TECHNICAL BULLETIN — AUGUST 2010

367. Tivoli Orbitor - Passenger Containment

Safety Bulletin

Bulletin No: RMSA003

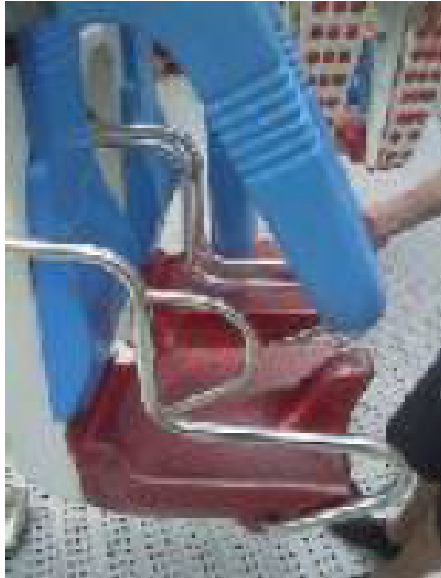
Purpose: Additional Side bar installation

An incident recently occurred where a passenger exited the ride seat on a ReMix II while it was in motion. At this time the incident is still under investigation. Although no similar incident has ever occurred in the United States since the initial delivery of this type of ride in 1999, Tivoli has elected to install an additional side bar on all types of ReMix Rides. This additional bar is shown in the photos below, and must be installed on all types of Remix rides as soon as possible.

As shown in the photos on the following page, the side bar additions are different on the 6 arm version than on the 4 arm version. This is because the lap bar locking cylinders operate differently on the 6 arm version than the 4 arm version, yet they perform the same function on both rides.

These side bar additions are to be welded into position On the outside bars either using TIG or MIG welding procedures. Welding should be completed by a certified welding technician with experience in welding stainless steel. All welds are to be cleaned and polished, removing all sharp edges when completed.
